RC13360L – Te Puna Industrial Limited, 297 Te Puna Station Road – Request for Further Information

Pursuant to Section 92(1) and (3) of the Resource Management Act 1991 ("RMA") Western Bay of Plenty District Council (WBDC) requests the following information:

Vehicle Access

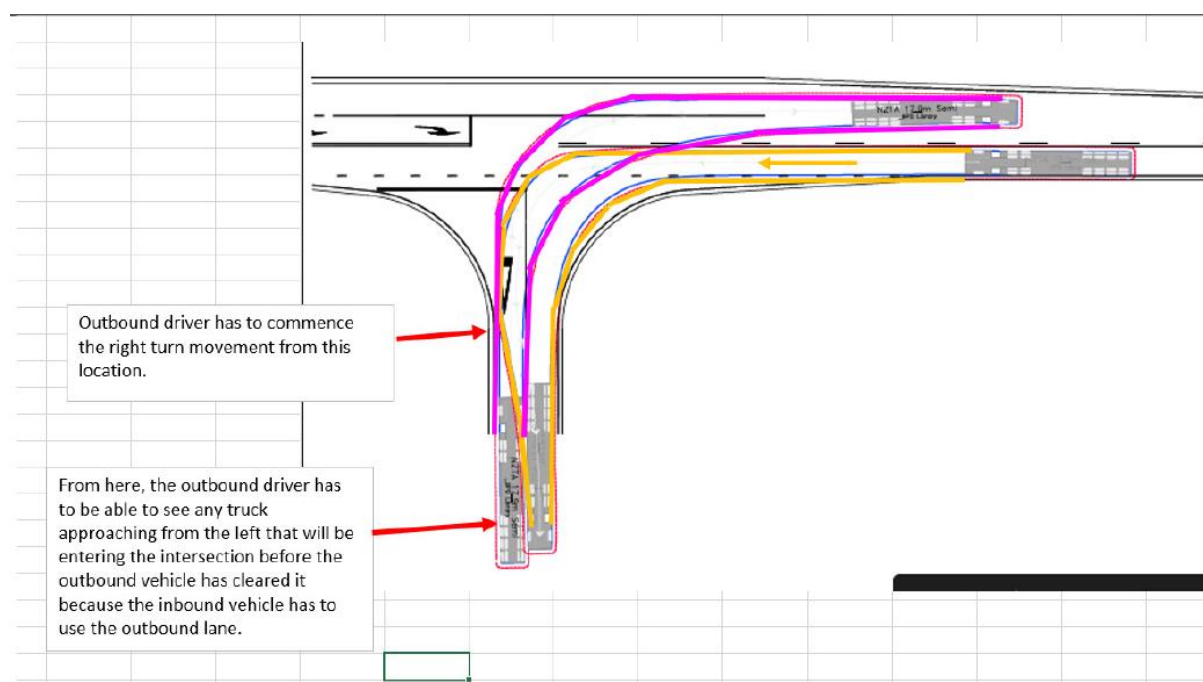
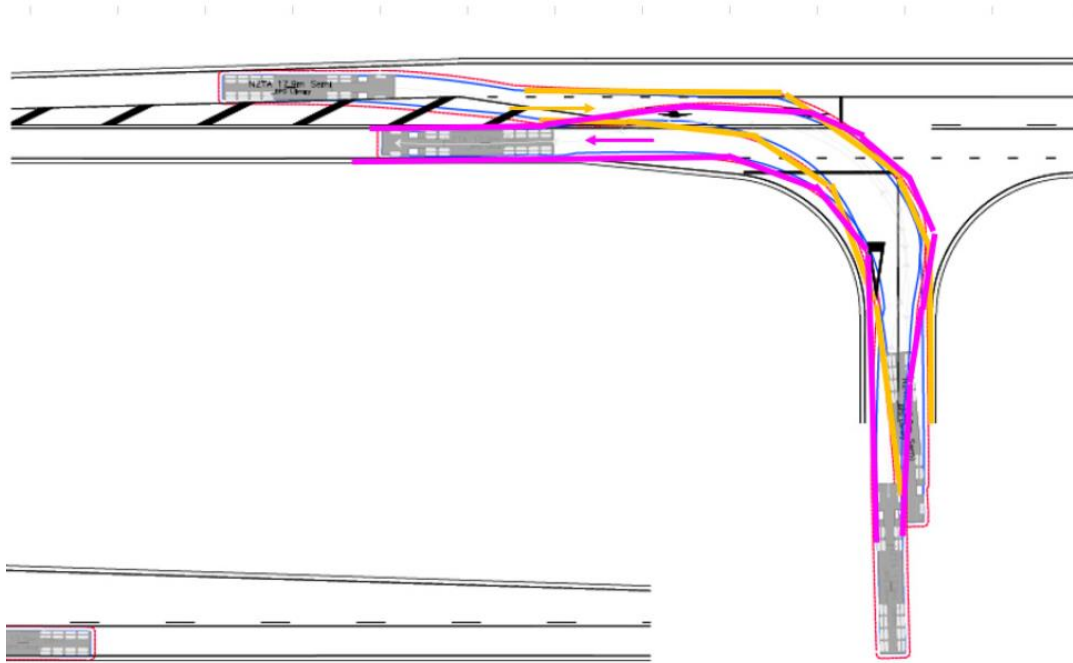
The proposed upgrade to the site access is severely deficient for truck movements and associated safe stopping sight distances. The design is fundamentally flawed and is designed to encourage head-on crashes on Te Puna Station Road, within the Road Reserve portion of the intersection and on the private road. It requires difficult manoeuvring and abnormal hold points. The tracking curves for the expected vehicles show full intrusion into oncoming lanes. This means that there is an inbuilt requirement for outbound vehicles to be checking for potential left turn inbound trucks well before reaching the limit line, and similarly, the inbound left turn trucks may end up having to stop mid turn to avoid an outbound vehicle. The following drawings show the outbound track in pink and the inbound track in orange.

10. Please provide revised drawings to address the fundamental flaws. Council does not accept the proposed design. We recommend that the intersection be re-designed to accommodate the tracking curves in accordance with industry best practise. Truck and trailer units must be able to stop where a limit line would normally be and then commence their turn from that point. Inbound and outbound trucks must be able to stay within their lane whilst turning. Due to the width that will be required across the throat, a splitter island (with flag lighting) is recommended to control speeds and angles.

11. Provide updated sight distances assessment, as appropriate to cater for heavy vehicles and adjusted to the surveyed speed if necessary (Safe intersection sight distance, Austroads).

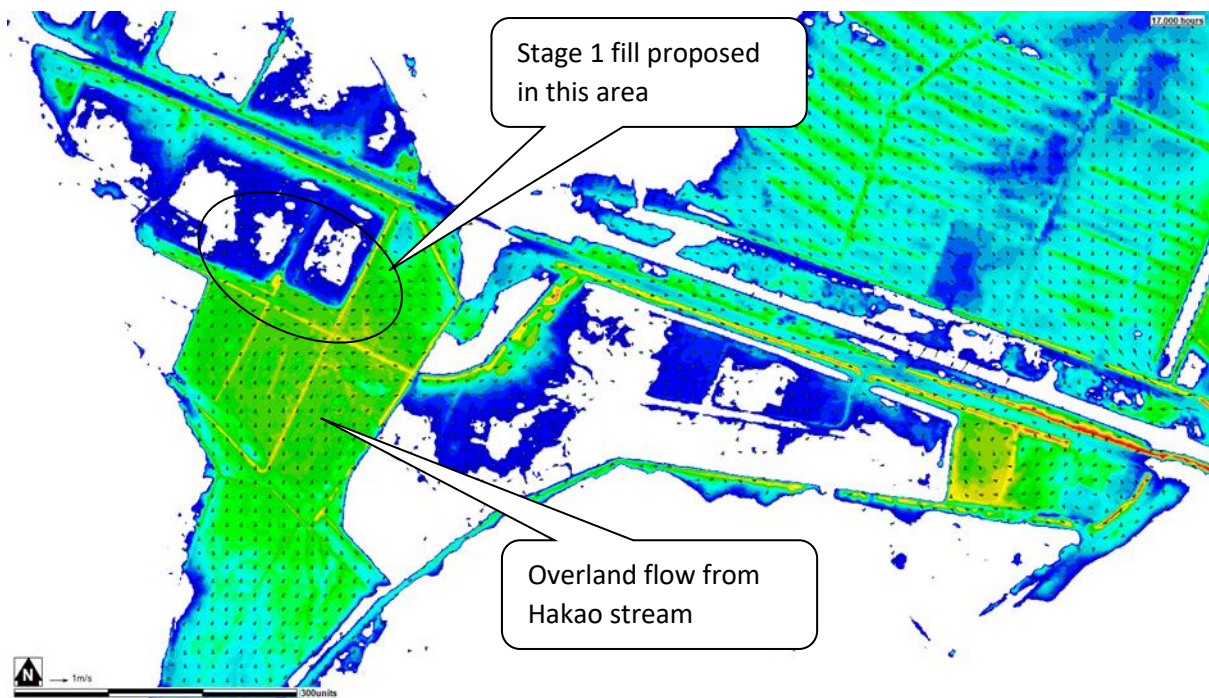
Section 5.2.1 indicates that the loss of flood storage caused by the additional fill will have "...negligible increase in flood level to surrounding properties.". The justification for this is that the area is sufficiently large to disperse the lost flood volume. We agree that, with backwater-induced flooding (which produces the highest flood levels in this area), this would be a fair assessment. However, we have noted that the cut-fill plan shows the majority of fill being placed on the part of the site that is shown to have the greatest flood depths, and includes fill over parts of existing drains. The overland flow direction in this area is likely to cross the south-western boundary of the site and pass northwards to Te Puna Station Road. The proposed placement of fill may affect the distribution of overland flow.

48. Please show how site drainage will be ensured after fill is placed that intercepts existing drainage on site.
49. Please show how the fill proposed for Stage 1 of the development will not affect overland flow in extreme events (when these occur without backwater effect) with the view to ensuring no adverse effect on off-site properties.
